## HISTORIC AND DESIGN REVIEW COMMISSION

**HDRC CASE NO:** 2016-021  
**COMMON NAME:** 200 S ALAMO  
**ADDRESS:** 223 S ALAMO ST  
**LEGAL DESCRIPTION:** NCB 14016 BLK 9 LOT 14(0.082AC), 16(0.335AC), & S IRR 409.04 FT OF 15(0.36AC)  
**ZONING:** D HS RIO-3  
**CITY COUNCIL DIST.:** 1  
**LANDMARK:** Hilton Palacio de Rio Hotel  
**APPLICANT:** Robert Thrailkill/Hilton  
**OWNER:** Zachry Corporation  
**TYPE OF WORK:** Exterior modifications  
**REQUEST:**

# HILTON PALACIO DEL RIO

RIVER'S EDGE CAFE PATIO & RIVER WALK ENHANCEMENTS

## CANOPY | BIRD'S EYE VIEW

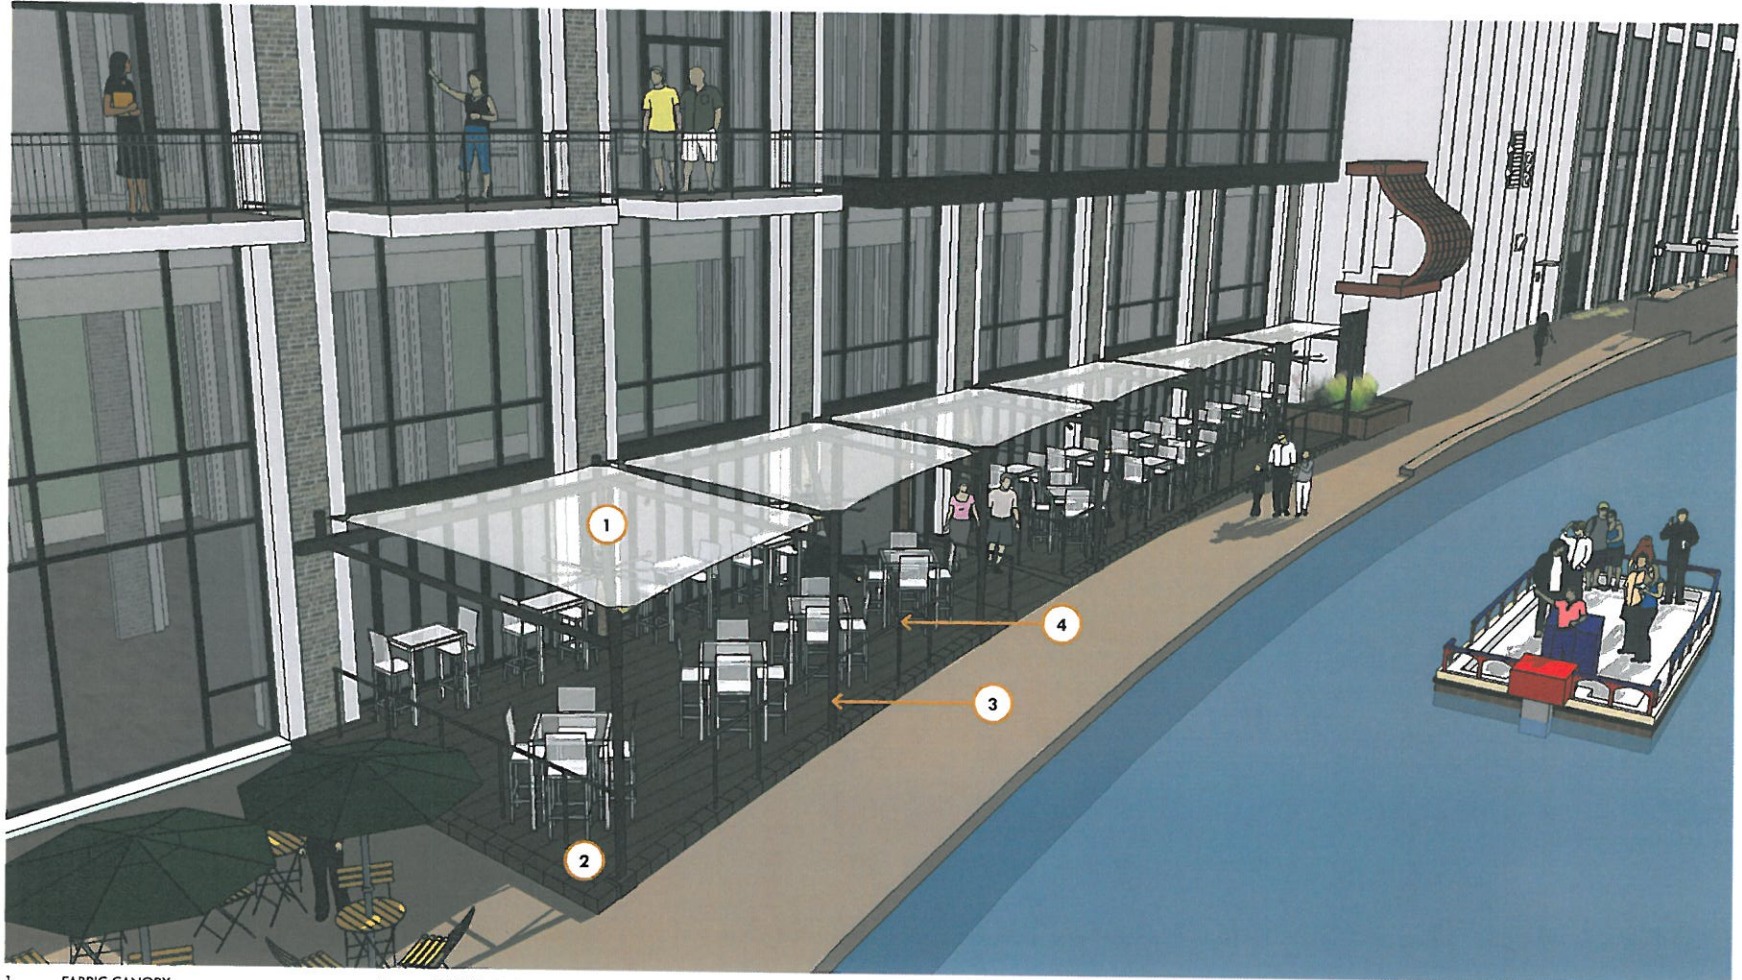
- d. The applicant has proposed a new outdoor canopy at the Riverwalk level that is to be composed of painted steel framing, painted railings, a fabric canopy and will feature ceiling fans for patron comfort. According to the UDC Section 35-674(g) regarding awnings, canopies and arcades, any awnings, canopy or arcade should be designed to accentuate the primary structure in form, proportions, materials, color and should include lighting that is incorporated into the design. The applicant's proposal is consistent with the UDC.
